# UNITED STATES PATENT AND TRADEMARK OFFICE

APPLICATION NO.	FILING DATE	FIRST NAMED INVENTOR	ATTORNEY DOCKET NO.	CONFIRMATION NO.
10/772,101	02/04/2004	Jacques Seguin	CVALVE.006CPI	6184
20995 7590 02/14/2007 KNOBBE MARTENS OLSON & BEAR LLP 2040 MAIN STREET FOURTEENTH FLOOR IRVINE, CA 92614			EXAMINER SCHILLINGER, ANN M	
			ART UNIT	PAPER NUMBER
			3738	
SHORTENED STATUTORY PERIOD OF RESPONSE		NOTIFICATION DATE	DELIVERY MODE	
3 MONTHS		02/14/2007	ELECTRONIC

**Office Action Summary**

## DETAILED ACTION

Attachment A

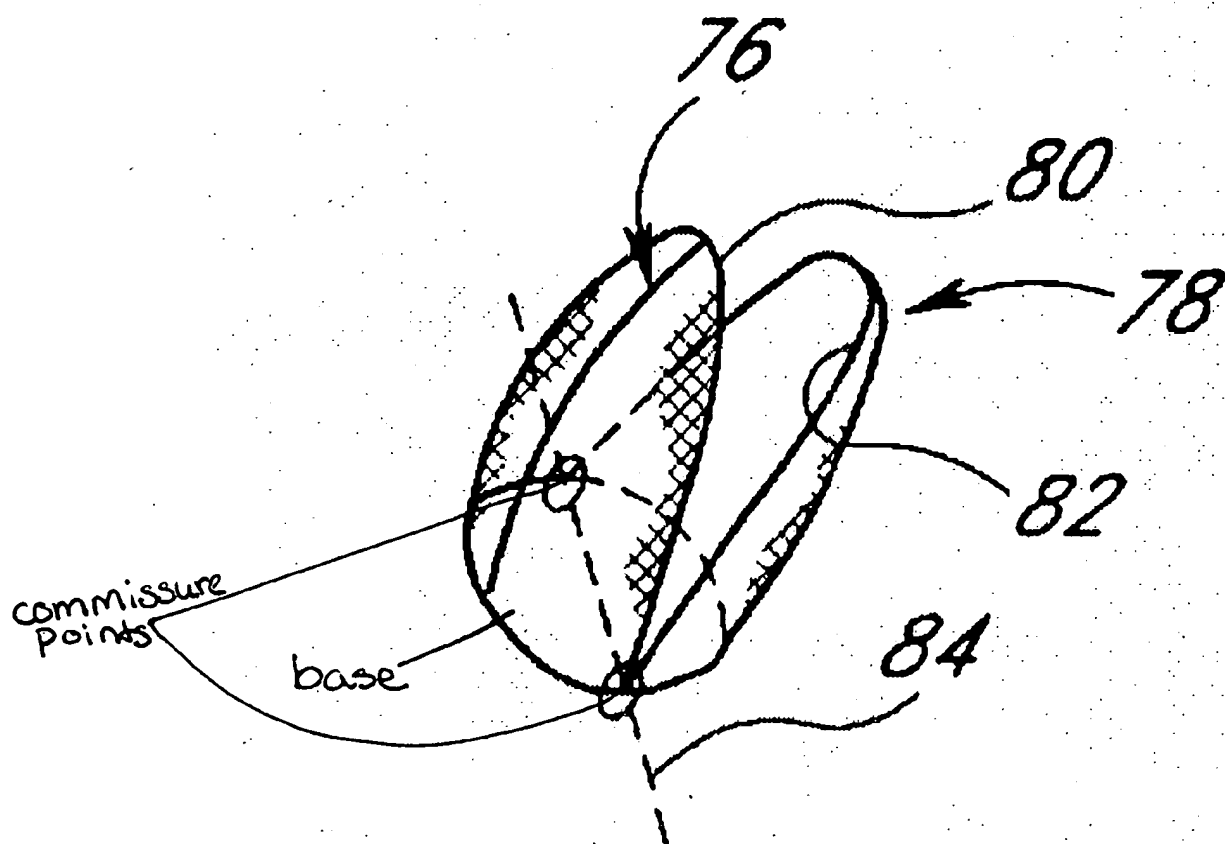
Claims 79-86, 88, 90-93, 96-104, and 110 are rejected under 35 U.S.C. 102(b) as being unpatentable over Shaolian et al. (US Patent No. 6,299,637). Shaolian et al. discloses the following of claim 79: a prosthetic valve assembly (40) for use in replacing a deficient native valve (30), the valve assembly comprising (col. 2, lines 55-58): a valve having a base (see

attachment A), a plurality of commissure points (see attachment A), and a plurality of resilient leaflets (76, 78); a valve support (44) configured to be collapsible for transluminal delivery (col. 5, lines 36-37) and comprising a single length of wire (col. 6, lines 63-64), a first portion (52) and a second portion (54), said first portion expandable to contact the anatomical annulus of the native valve (30) when the assembly is properly positioned, said second portion supporting the base and the commissure points of the valve (50 or 54); and a radial restraint for controlling a diameter of the second portion (col. 5, lines 36-41; Figures 1, 4, 6); wherein the single length of wire has a reduced thickness to decrease the radial expansion force (see Figure 1, and explanation applied to claim 16, above).
